**CHAMPAIGN COUNTY BOARD  
COMMITTEE OF THE WHOLE – ELUC/Highway/County  
Facilities**

**ENGINEER'S PRELIMINARY OPINION OF PROBABLE CONSTRUCTION COSTS  
SCHEMATIC DESIGN PHASE  
NORTH WATERSHED STORM WATER MANAGEMENT  
CHAMPAIGN COUNTY EAST CAMPUS SITE**

**PROJECT: NORTHERN WATERSHED STORM WATER MANAGEMENT  
CHAMPAIGN COUNTY EAST CAMPUS  
URBANA, CHAMPAIGN COUNTY, ILLINOIS**

**ITEM: Response to Questions and Suggestions  
Jim Patchett, Conservation Design Forum  
Memorandum of October 4, 2011**

**BEST MANAGEMENT PRACTICES APPROACH**

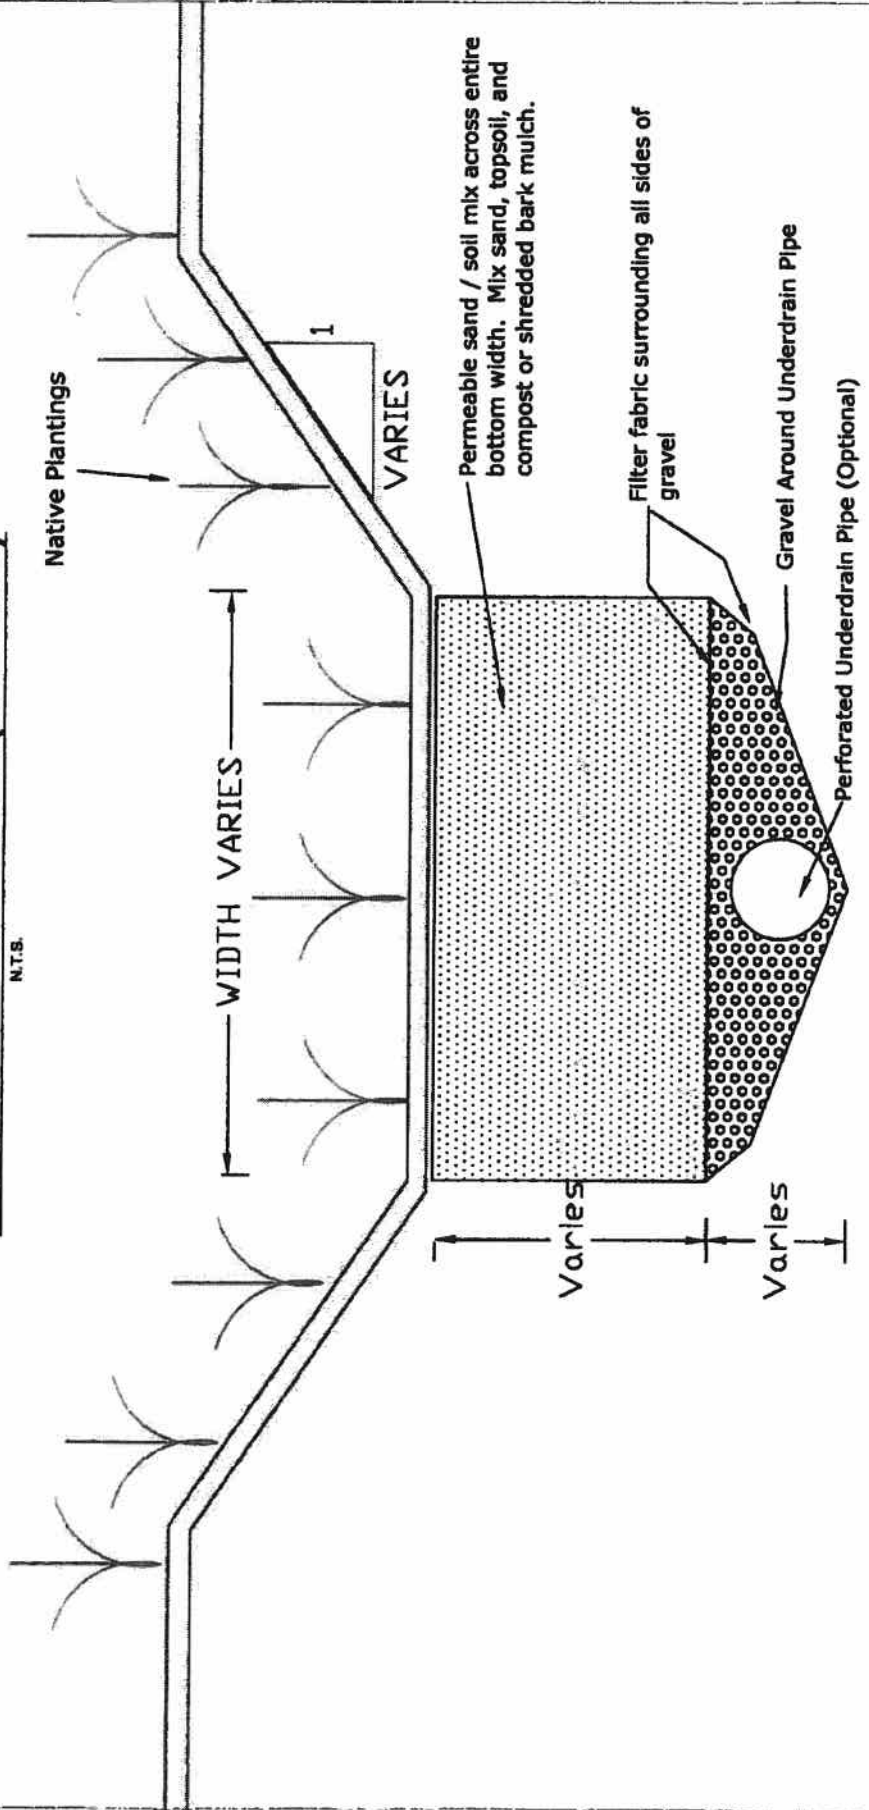
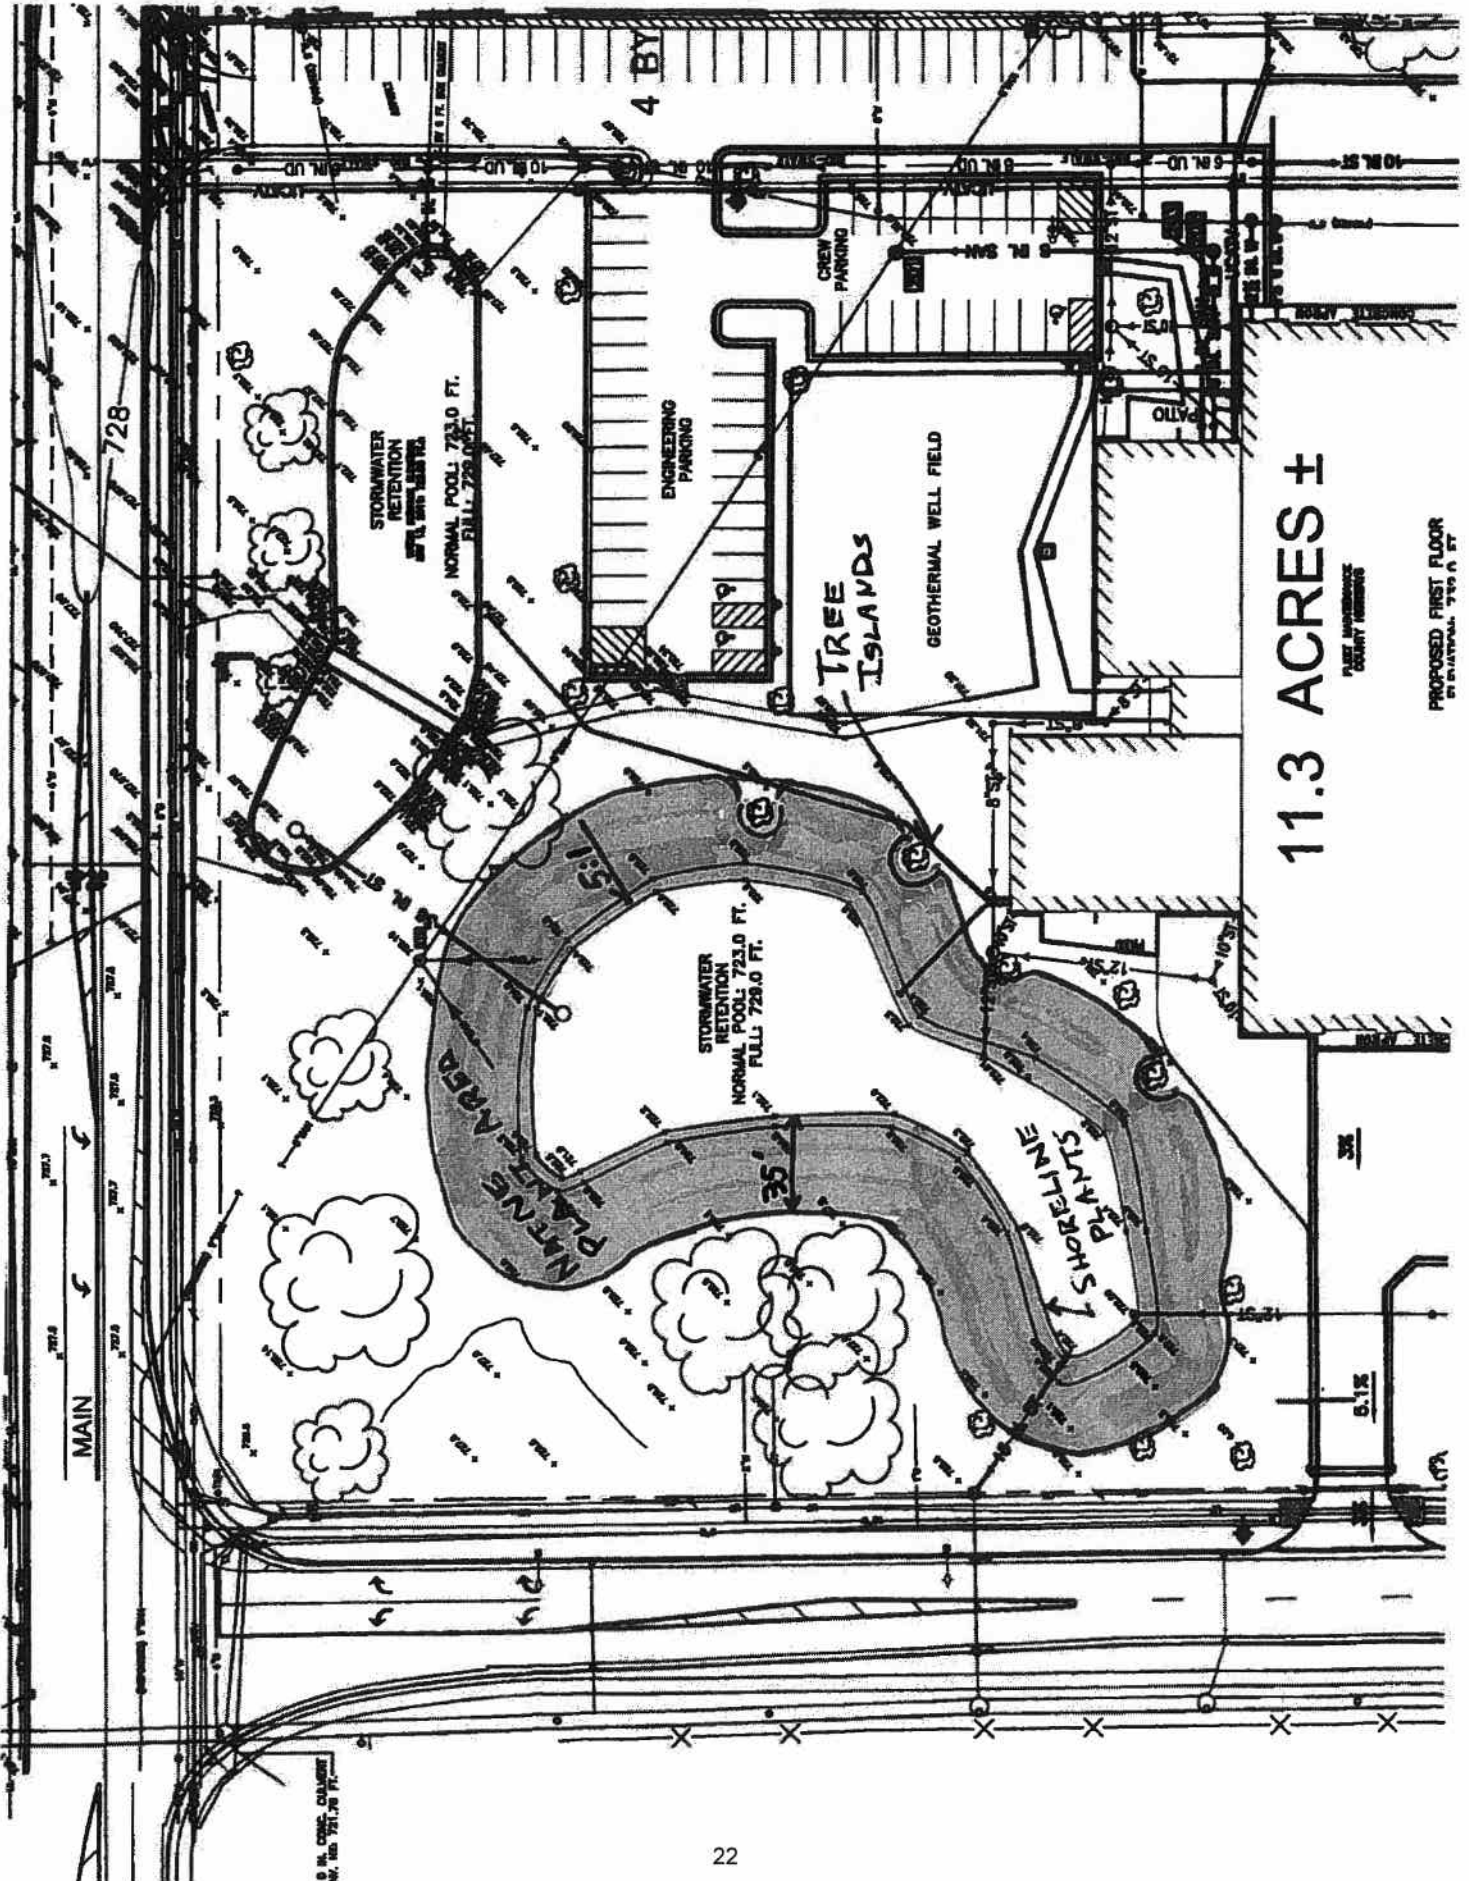
The Best Management Practices Approach design submitted by BCA proposes Bio-swales & Rain Gardens either across or through these known easements. If the BMP approach is implemented for this project, at any time, any of these utility companies may access these areas to perform repairs or replacements, forcing us to reconstruct the area affected.

The BMP approach utilizes approximately 3 acres of space located around the EOC and ILEAS facilities, greatly reducing the possibility of building and/or parking lot expansions for these properties.

The Wetland Basin proposed directly north of the Juvenile Detention Facility in the BMP approach will force the area used by the EOC for a Helicopter landing site to be moved further away from their building deeper into the East Campus.

**BEST MANAGEMENT PRACTICES APPROACH**

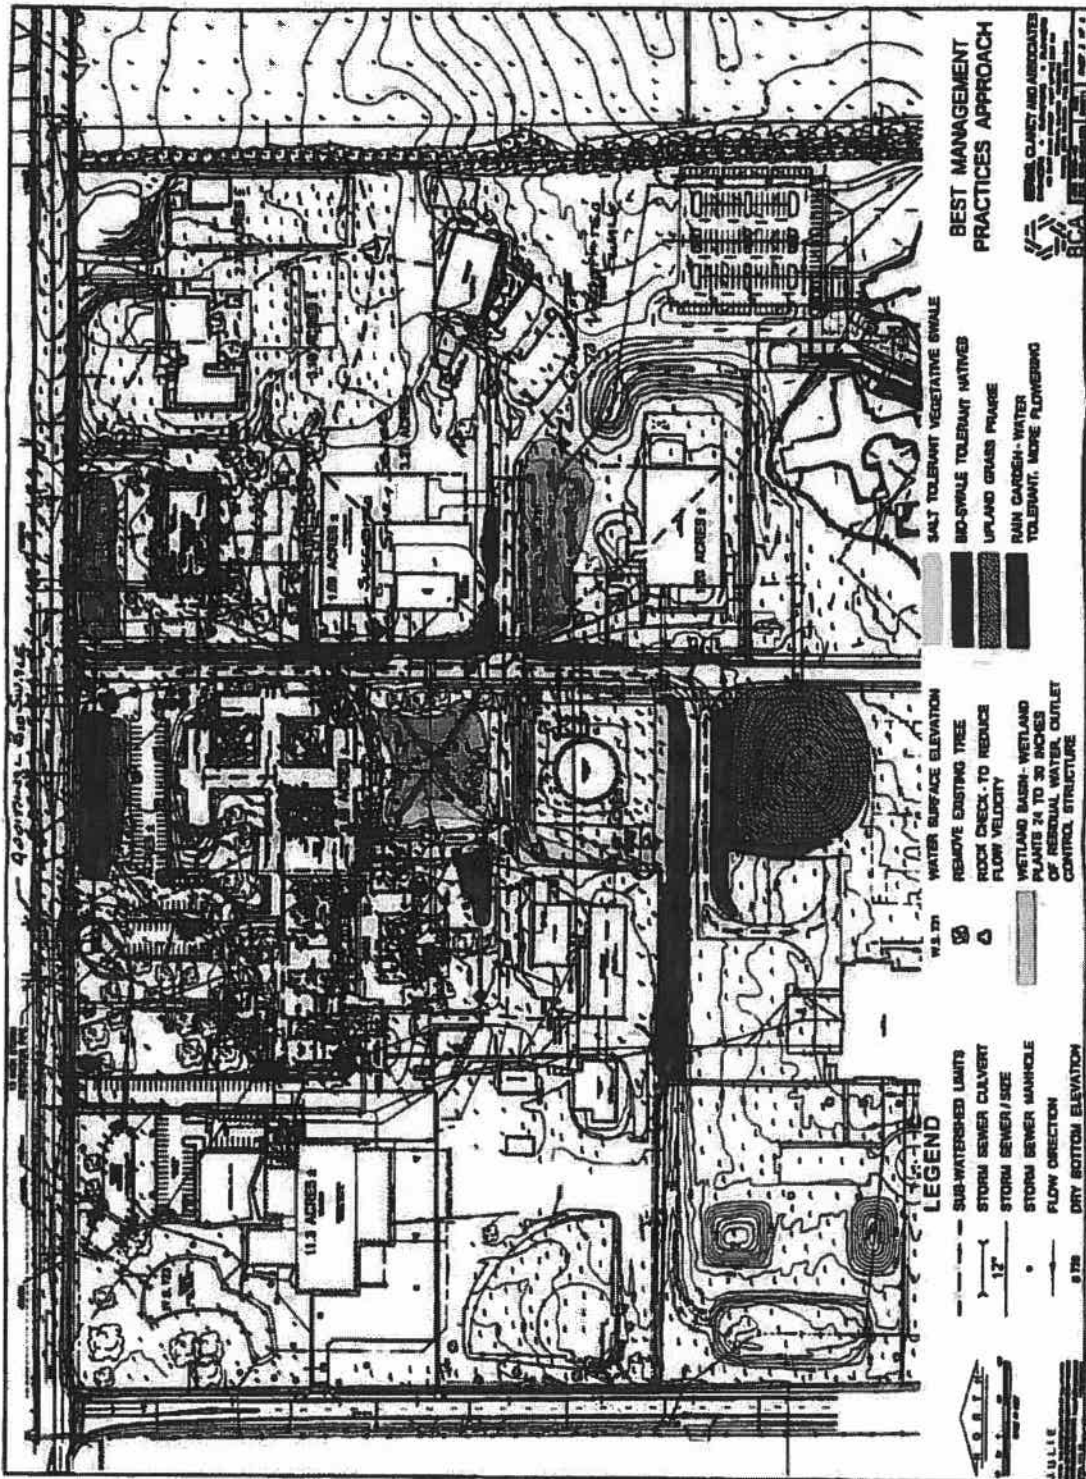
Attached is a marked up copy of Berns, Clancy and Associate's Best Management Practices Approach to solving the storm water management problem at the east campus. Davis Atchley, PE, PLS at MSA Professional Services assisted in the preparation of the following comments as a courtesy to the County.

- Planting salt tolerant grasses around the salt dome is a good idea.
- Planting an upland grass prairie on the mound located south of the salt dome is a good idea.

- Eliminate the proposed wetland basin on the east side of Art Bartell Road and replace it with a vegetated swale.
- Eliminate the wetland basin north of the salt dome, grade to drain and replant with grasses as needed.

- Construct a storm sewer south near Main Street a sufficient distance and of a sufficient size to carry the water from the southerly portion of the area through the high spot to the existing detention at the maintenance facility.

- Increase the size of the bio-swale / rain garden / detention along Main Street as needed.
- Constructing the bio-swailes along the roadways with an under drain is good practice from a highway engineering perspective. Under drains would also discourage the growth of cat tails. It should also be noted that salt runoff from the salt dome area would react with clay in the bio swales and make the bio-swailes less pervious. Therefore it's a good idea to construct the bio swales in the salt dome area with low clay content soils.

We attach a copy of the letter from County Board Member Gary Maxwell we received for your reference. This letter is a suggestion to modify the proposed Best Management Practices Approach into another alternative. The major components of this new alternative removes some "Hybrid" Approach Best Management Practices and utilizes more components of a standard storm sewer approach which are summarized as follows:

1. Salt tolerant grass around the Salt Dome is retained.
2. Upland grass prairie on the earth mound is retained.
3. The wetland basin Best Management Practice east of Art Bartell Drive is deleted and replaced with a vegetated swale thereby reducing excavation and planting costs.

4. The wetland basin Best Management Practice north of the Salt Dome is deleted and replaced with a grassed, dry stormwater detention area thereby reducing excavation and planting costs.

5. Extend a 24 inch diameter storm sewer along the eastern edge of Art Bartell Drive from Main Street south to the access drive to the Humane Society to convey runoff through the high spot.

6. Increase the size of the proposed storm sewer south of Main Street from Art Bartell west to the existing storm water detention basins from 24 inch diameter to 48 inch diameter to transfer the increased runoff from the south (the new storm sewer) at an increased rate to the existing storm water detention basins.

7. Add bio-swale area to the west of the north driveway to I.L.E.A.S.
8. Bio-swales will continue to include underdrains.
9. Bio-swales will be constructed with amended topsoil as natural soils are typically very tight. Clay soils will be minimized in the areas around the salt dome area.
